## **DETONTI PLACE SUBDIVISION**

APPLICATION NUMBER 6 DATE May 6, 2021

REQUEST Subdivision

# DETAIL SITE PLAN

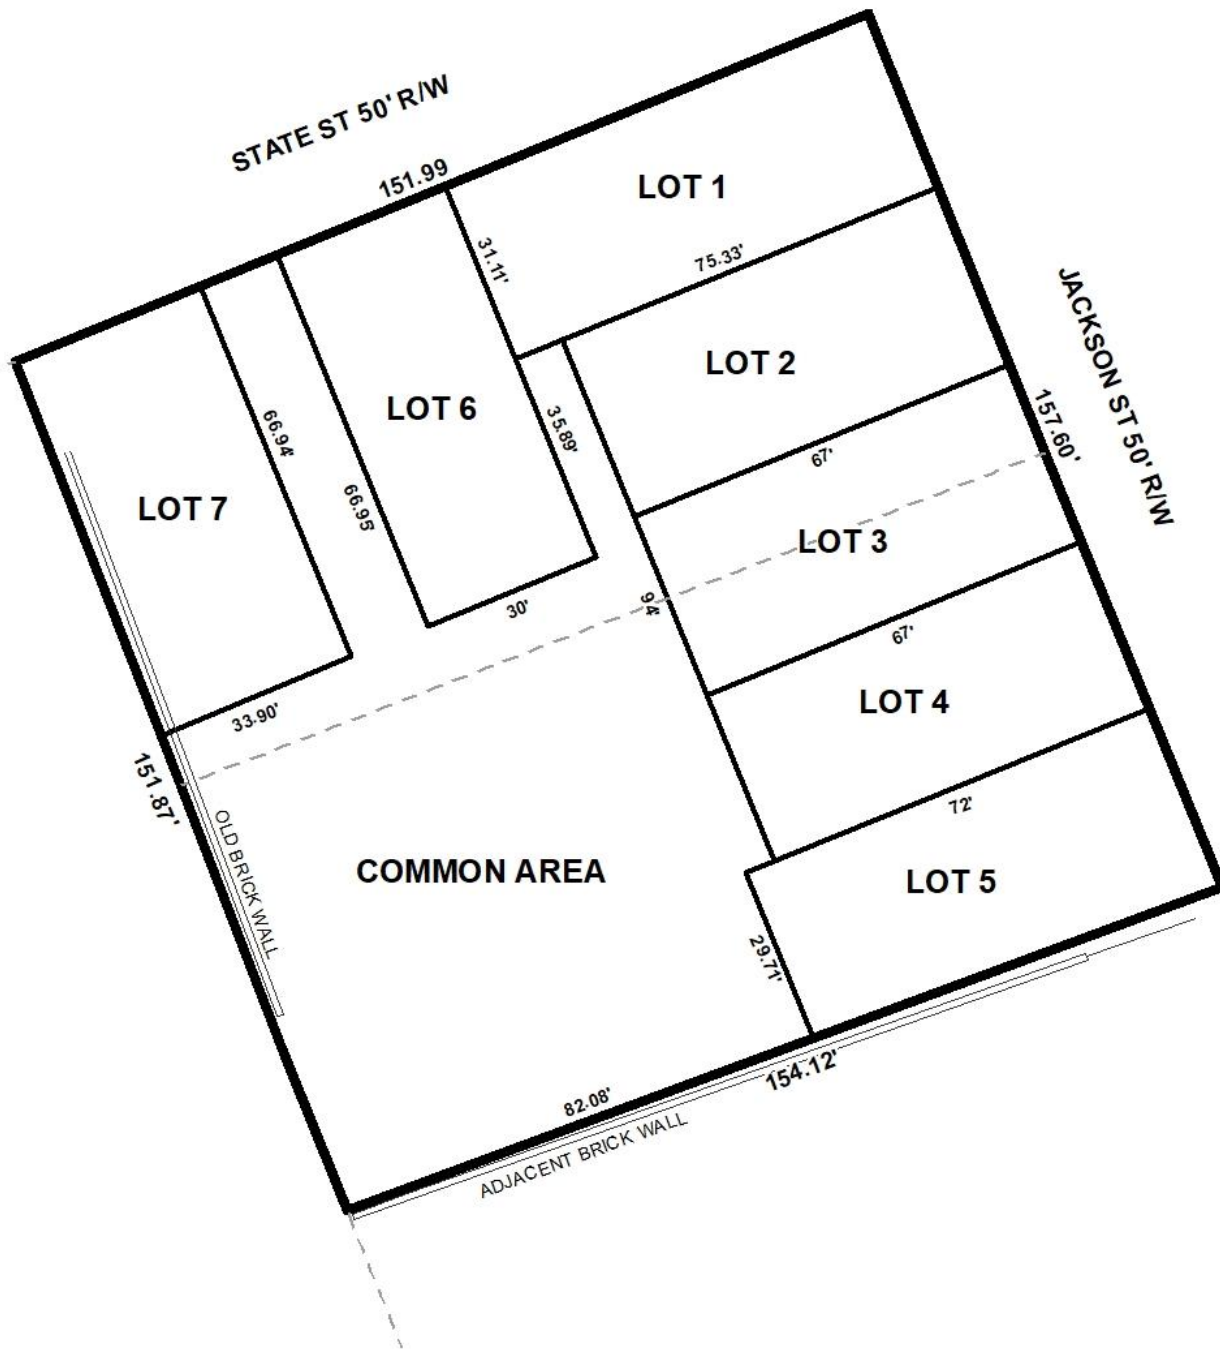
Per Section 64-3.I.8.(d), the DDD allows a twelve-foot maximum setback along all street frontages in T-4 Sub-districts. The preliminary plat shows no setback requirements. If approved, the Final Plat should be amended to depict or label a maximum building setback of twelve feet along both street frontages. As this differs from the standard 25-foot minimum setback required by Section V.D.9. of the Subdivision Regulations, this section will need to be waived, if approved.

The preliminary plat provides the lot sizes in square feet and acres. Therefore, if approved, this information should be retained on the Final Plat, or a table should be furnished on the Final Plat providing the same information. As per Section 64-3.I.10.(a), property coverage by all buildings in T-4 Sub-districts shall not exceed 75 percent of the net property area. A note should be required on the Final Plat stating such.

Section 64-3.I.11.(c)(3) limits the driveway width to ten feet within the front setback along primary frontages. A note should be required on the Final Plat stating such. As per the Traffic Engineering comments, each lot is limited to no more than one curb cut per street frontage with size, location and design to be approved by Traffic Engineering and conform to AASHTO

The plat indicates a Common Area intended for parking. A note should be required on the Final Plat stating that the maintenance of the Common Area is the responsibility of the property owners.

- 1) retention of the right-of-way widths of North Jackson Street and State Street on the Final Plat;
- 2) revision of the plat to depict or label a maximum building setback line of twelve feet along both street frontages;

- 3) retention of the lot sizes in both square feet and acres, or the furnishing of a table on the Final Plat providing the same information;
- 4) placement of a note on the Final Plat stating that site coverage by all structures shall not exceed 75 percent of the net property area;

- 5) placement of a note on the Final Plat stating that driveway width is limited to ten feet within the front setback;
- 6) placement of a note on the Final Plat stating that the maintenance of the Common Area is the responsibility of the property owners;
